**International
Aero Engines**

Subject: Transmittal of Revision 1 to Service Bulletin No.V2500-ENG-79-0064

V2500-ENG-79-0064

ENGINE – MAIN GEARBOX ASSEMBLY – INTRODUCTION OF REVISED OIL SCAVENGE
TUBES TO STOP OIL LEAKS

Figure 1
Scavenge oiltubes - Gearbox - Filter to oil tank (A1/A5)

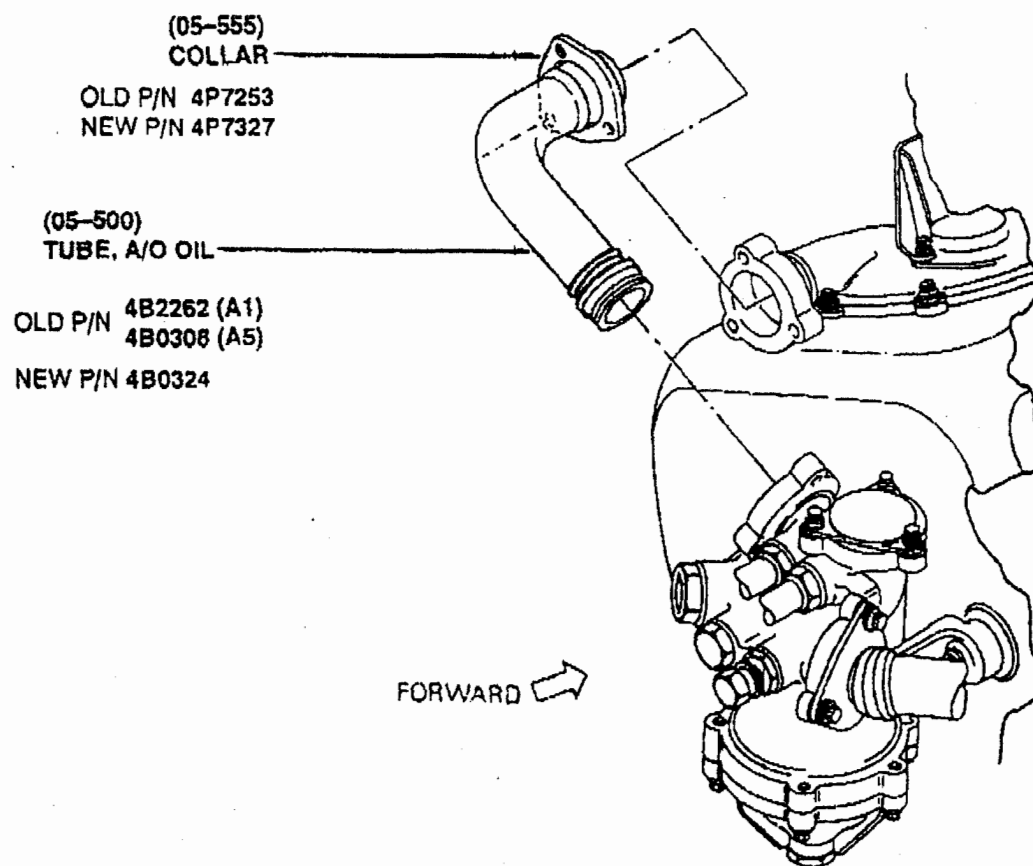
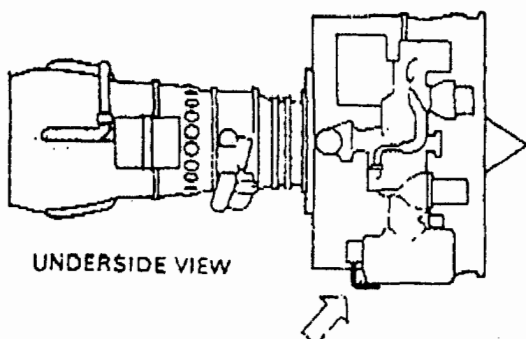
(1) The oil tubes for the gearbox have changed as follows:

- (a) A different sleeve has been installed on the oil tubes.

Figure 3
Scavenge oil tubes - Gearbox - Filter to oil tank (D5)

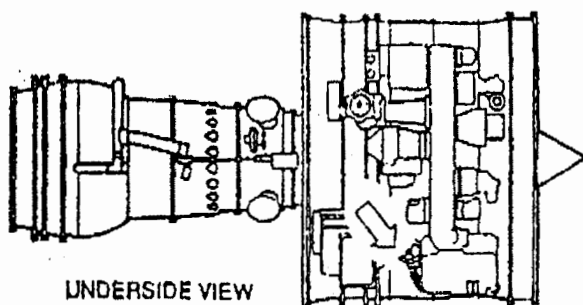
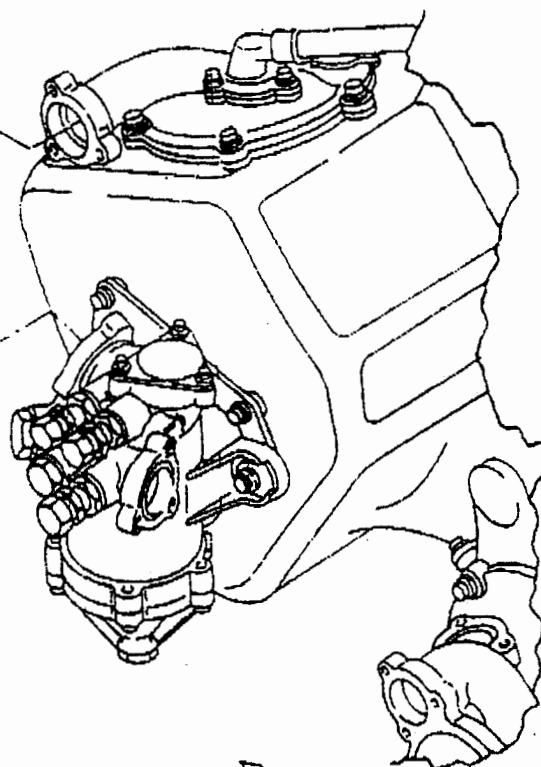
(05-535)
COLLAR
OLD P/N 4P7253
NEW P/N 4P7327

(05-500)
TUBE, A/O SCAV. GBX

OLD P/N 4B2261
NEW P/N 4B2298
